PLUG AND ABANDONMENT PROCEDURE

Rosa Unit #351A

Re: Permanent Abandonment
Well: Rosa Unit #351A

CONDITIONS OF APPROVAL

ROSA UNIT #351A
BASIN FRUITLAND COAL
Proposed P&A

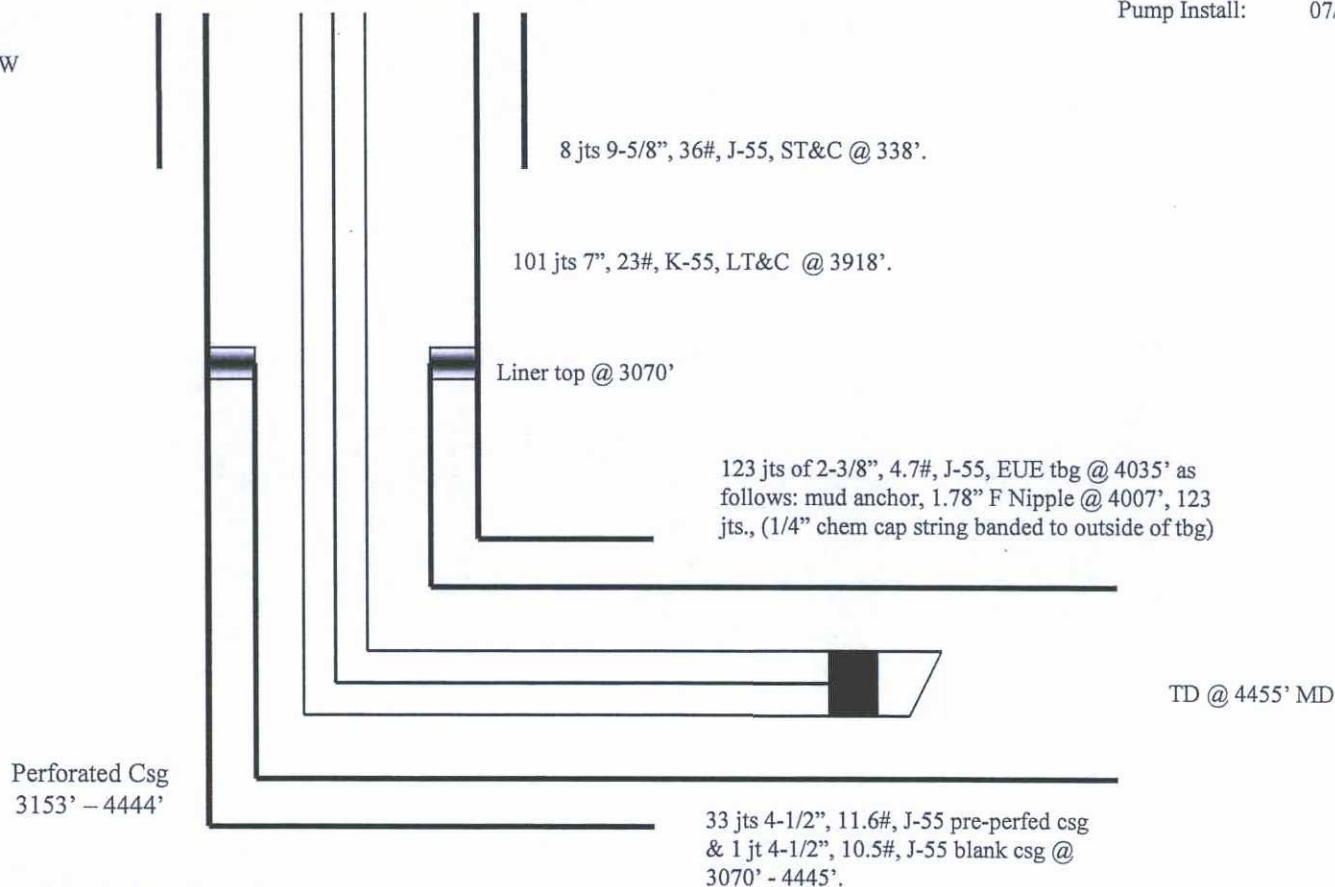
Ensure inside plugs are designed as 100' plugs plus 50' of excess similar to BLM condition 4.5 attached to this application. This condition will change the following plugs;

- Pump a cement plug underneath the cement retainer set at 3060'. The plug needs to be calculated to cover inside and outside the casing down to 3310 plus 100% excess to properly cover Fruitland top

1. Plugging operations authorized are subject to the attached "General Requirements for Permanent Abandonment of Wells on Federal and Indian Lease."
2. Farmington Office is to be notified at least 24 hours before the plugging operations commence (505) 564-7750.
3. The following modifications to your plugging program are to be made:
 - a) Set plug #2 (1659-1559) ft. to cover the Nacimiento top. BLM picks top of Nacimiento at 1609 ft.

Operator must run CBL from CR to surface to identify TOC. Submit the electronic copy of the log for verification to the following addresses: jwsavage@blm.gov Brandon.Powell@state.nm.us

You are also required to place cement excesses per 4.2 and 4.4 of the attached General Requirements.
